**PCO #074**

**Project:** 21-501 - Collin County Adult Detention Facility, Phase 1 Addition  
 4300 Community Avenue  
 McKinney, Texas 75071

**Prime Contract Potential Change Order #074: RFI #192 ADD Floor Sink Due to Conflict with AHU-1**

[P221\\_LEVEL1 EAST FLOOR PLAN - SANITARY\\_VENT Rev.0 markup.pdf](#)

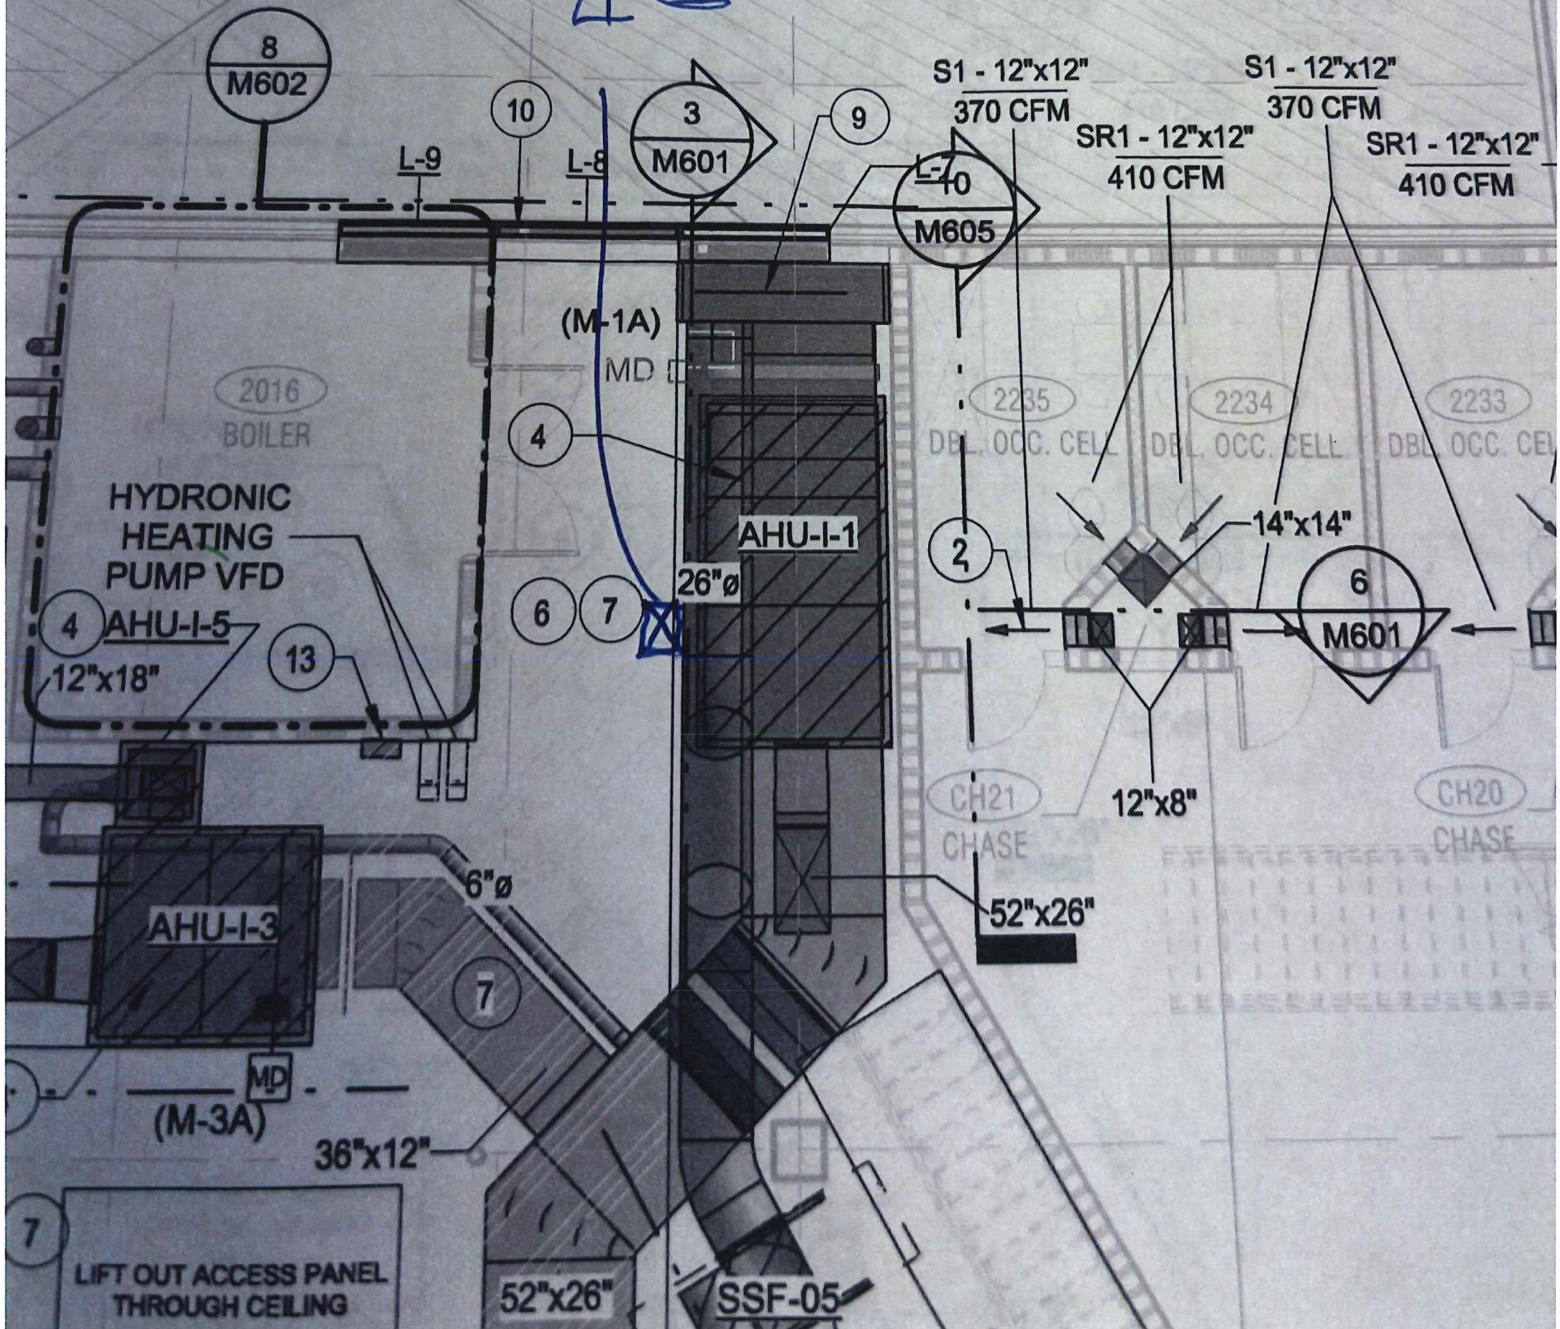
On sheet P221 there are 2 floor sinks (FS-2) that are installed per the contract drawings on level one in room 2014. However the floor sink is in the center of AHU -I-1. This floor sink is not for condensation lines. Can we abandon this floor sink, or do we need to install a new floor sink out of the way of the mechanical pad/air handler? If we need to relocate both these floor sinks, please provide the new location for them.

The floor sinks are for condensate lines. The FS in conflict AHU-I-1 can be abandoned, but it should be plugged to prevent sewer gas from entering the space. Another FS should be installed further plan south as needed to not conflict with the unit. GC to coordinate exact location in field.
